## ***Interactive comment on “The characteristics of lightning risk and zoning in Beijing simulated by a risk assessment model” by H. Hu et al.***

**H. Hu et al.**

Received and published: 8 October 2013

Fig. 1.

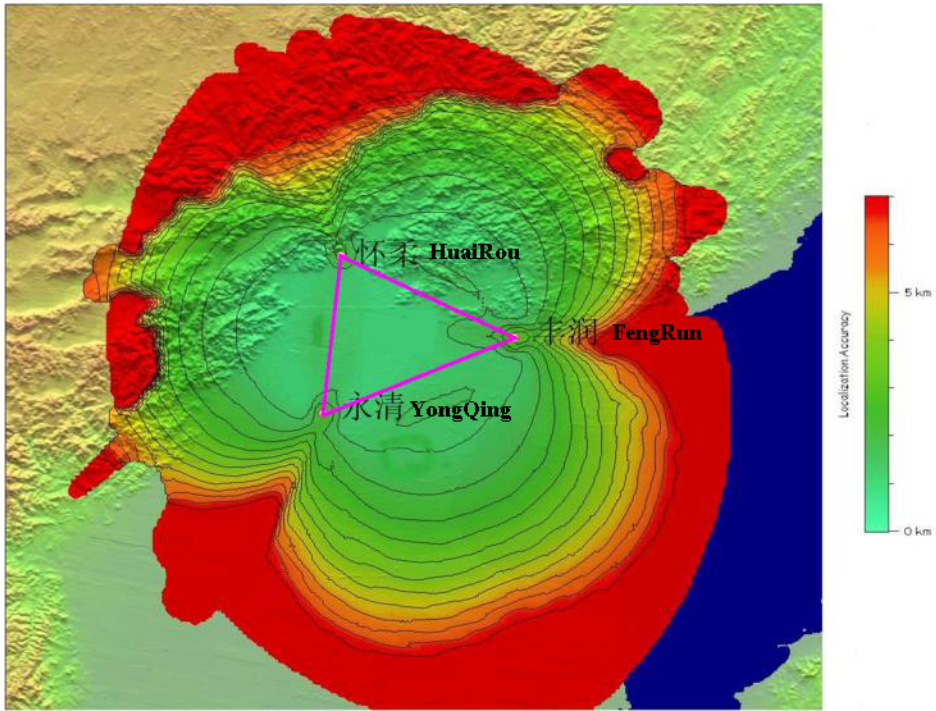
1. Page 4119, lines 18-19 and 25: The authors mention “accurate” angular localization. This wording is undefined. The accuracy of direction finding is typically several degrees and, thus, quite bad. However, for the present analysis, the VHF part of Safir is not relevant as it is unable to detect CG strokes. For the present paper, only CG strokes are relevant, and these are detected by the LF part of the Safir system. Thus, when the authors comment location accuracy of the LF part of the used Safir system, they should clearly refer to the LF part and clarify whether the LF part uses direction finding or TOA techniques. The location accuracy is claimed to be better than 1 km. This is

in marked contrast to all data comparisons between Safir and more modern systems. Maybe the authors just clarify that the quoted accuracy may reflect a manufacturer expectation. Reply: The “accurate” here is improper, so we delete it. The SAFIR 3000 surely uses the TOA techniques for characterizing the CG. We have corrected it. The location accuracy is determined by the coverage of the stations. Because the distances between two of the sensors of SAFIR are only about 126-145 km, the accuracy is nearly 1-2 km in most areas of Beijing (Seeing the appended figure 1). We have corrected it.
